## Edmundson Plaza

Docket Item #14 A-C

Development Special  
Use Permit #2006-0023 (A)

Planning Commission Meeting  
June 5, 2007

Figure 16: Proposed Open Space

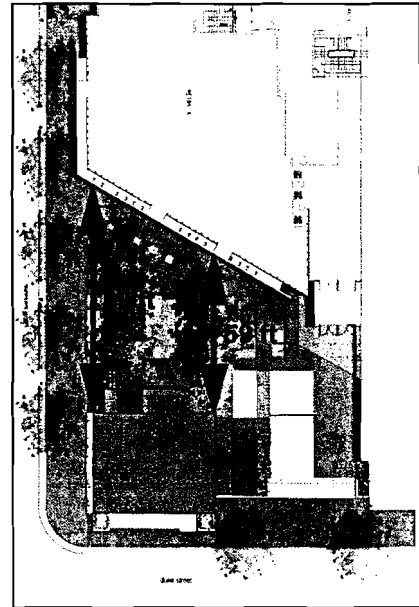
With the multiple purposes and opportunities of this open space courtyard in mind, staff has included recommendations to enhance its quality, to make the open space area more compatible with the existing and proposed buildings, and to provide an appropriate memorial to the historic site. These changes include:

- Increasing the amount of landscaping and trees in the open space area to form a courtyard around the historic building;
- Requiring that the open space/courtyard area consist of a portion with lawn or planted area;
- Creating an appropriate gathering area and memorial within the courtyard area to commemorate the solemn history of this site, such as a fountain or sculpture;
- Creating a clear separation between the courtyard area and any outdoor activity space of the new office building so that such things as outdoor dining can coexist harmoniously with the memorial area; and
- Requiring final design approval of the open space courtyard and memorial by BAR.

7. **REVISED BY PLANNING COMMISSION:** The open space area on the southern portion of the site shall provide amenities such as special paving surfaces, materials, benches, trash receptacles, landscaping, etc. to encourage its use to the satisfaction of the Directors of P&Z and RP&CA. In addition, the open space shall be reviewed and approved by the Old and Historic Board of Architectural Review:

- c. A public focal element such as a sculpture or fountain that is an appropriate scale for the space shall be provided and permanently mounted within the open space. Provide, at a minimum, two decorative benches and one trash receptacle in the courtyard open space area of the site.

Figure 20: Setback Modifications

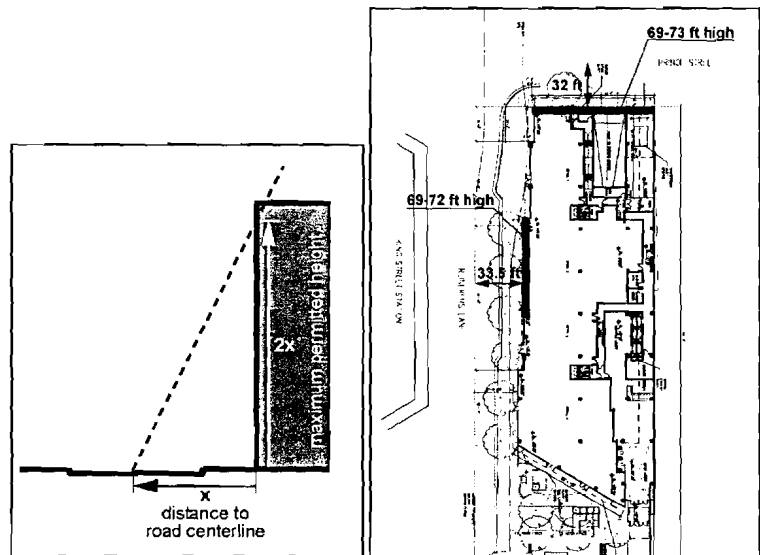
Although the OCH zone does not have yard requirements, the Zoning Ordinance requires that the building be set back from the centerline of the street it faces a distance equal to at least half the height of the building at every point. In this case, one key factor warrants a modification of this technical requirement along Prince Street and a portion of the building along Reineker's Lane. The early Metro development of the King Street Station Shops complex and the building at the intersection of Diagonal and Daingerfield Roads "shifted" the roadway at this location resulting in an offset alignment of the road.

The height of the building along Prince Street varies due to the grade change of the street sloping down about four feet from the intersection of Reineker's Lane to the eastern edge of the property. Along Prince Street, the proposed building varies in height from 66 to 70 feet, with a setback of 32 feet from the centerline. The setback rule requires a setback of 33 to 35 feet, resulting in a requested modification of 1 to 3 feet. Along Reineker's Lane, the portion of the building that does not meet the setback requirements is 72 feet tall with a 33.5-ft. setback from the centerline. The setback rule requires a 36-ft. setback from the centerline of Reineker's Lane, and therefore a 2.5-ft. modification is required.

Figure 24: Proposed Vacation

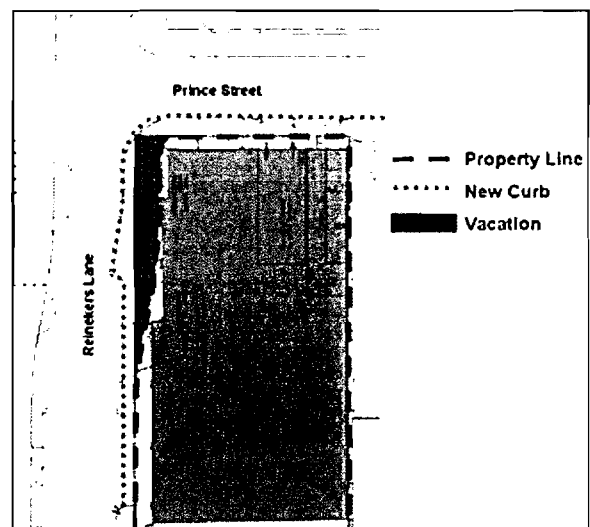
Staff is recommending approval of the proposed vacation of approximately 910 sq. ft. for the underground garage. While not ideal, the vacation is needed due to the narrow width of the site. While staff is recommending approval, the approval is contingent on the following:
